ADDENDUM NO. 02

PROJECT NAME: **OLMOS BASIN PARK**

TCI PROJECT NO.: **40-00381**

ITEM NO. 3. SHEET S2.1: FRAMING DETAILS

SHEET TITLE
FRAMING
DETAILS

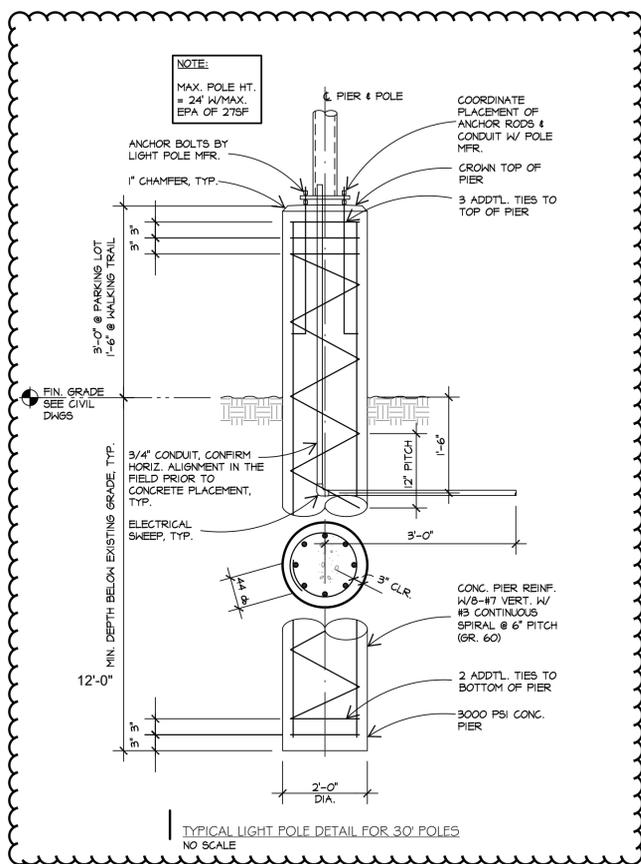
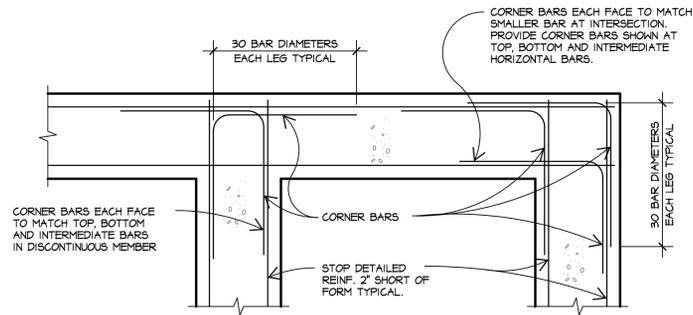
- ITEM NO. 1.** Footings for the 15' trail light poles shall follow the Electrical Engineer's detail. Refer to Sheet E3.1, Detail 4.
- ITEM NO. 2.** Footings for the 30' parking light poles shall follow the Structural Engineer's detail. Refer to revised Sheet S2.1, Detail 1 below.

- A. Replace previously issued sheet, dated June 13, 2014 with the attached revised and reissued drawing dated **September 23, 2014**.
- 1) Revised depth of footing below grade.
